WATER QUALITY MEMORANDUM

Utah Coal Regulatory Program

SUBJECT: 2009 3rd Quarter Water Monitoring, CW Mining Company, Bear Canyon Mine, C/015/0025, Task ID # 3373

Lower Right Fork Bear Creek (BC-3)

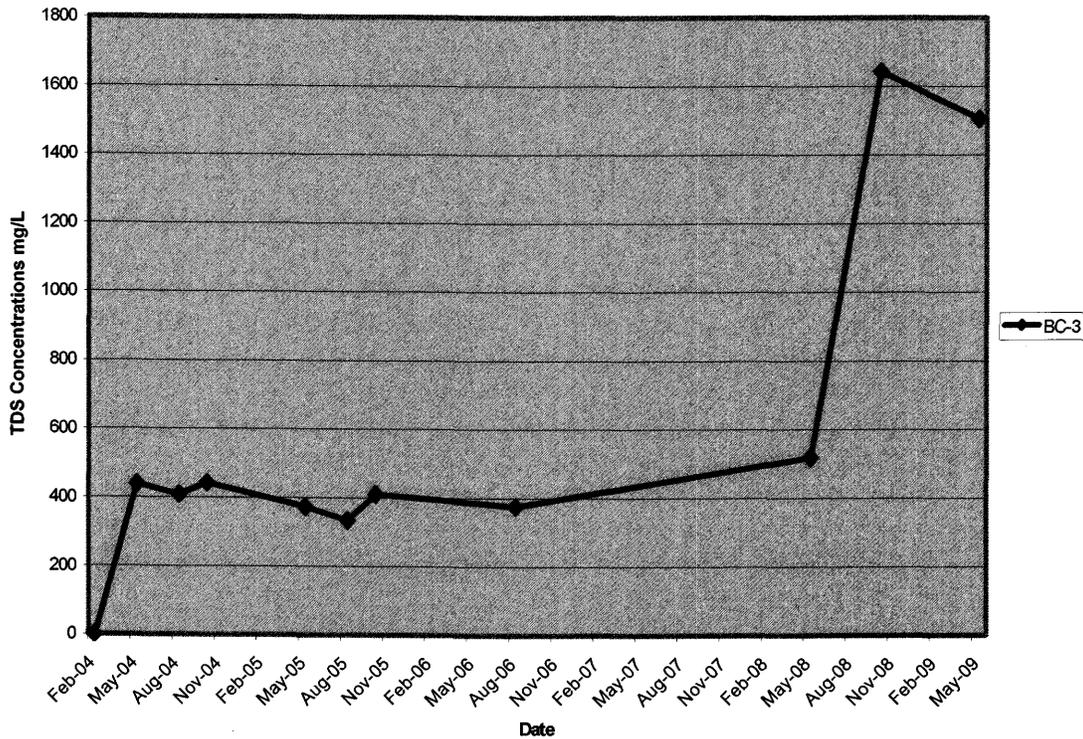
Sample BC-3 at the Lower Right Fork of Bear Creek has shown a recent increase in the levels of Total Dissolved Solids (TDS) since Fall 2008. Prior to this increase, TDS levels have averaged around 400 mg/L since 2004 (see chart below). This sample location was dry in August and September 2009 and therefore, a TDS data point could not be collected.

- Sample BC-3 at the Lower Right Fork of Bear Creek has shown a recent increase in the levels of Total Dissolved Solids (TDS) since Fall 2008. This indicates that excess sediment may be discharging into the creek. The operator should evaluate sediment controls in this area and determine if there is any mitigation needed to control the level of sediment entering the water body. The location of stream sample BC-3 is an important one due to the fact that it is located adjacent to the main road. A high likelihood of this area receiving sediment from the disturbed area exists. Therefore, the Division recommends that Permittee modify the water monitoring plan to sample this location for operational parameters whenever flow is present. Currently, the water monitoring plan only requires the location be sampled for operational parameters during the months of February, August, and October.
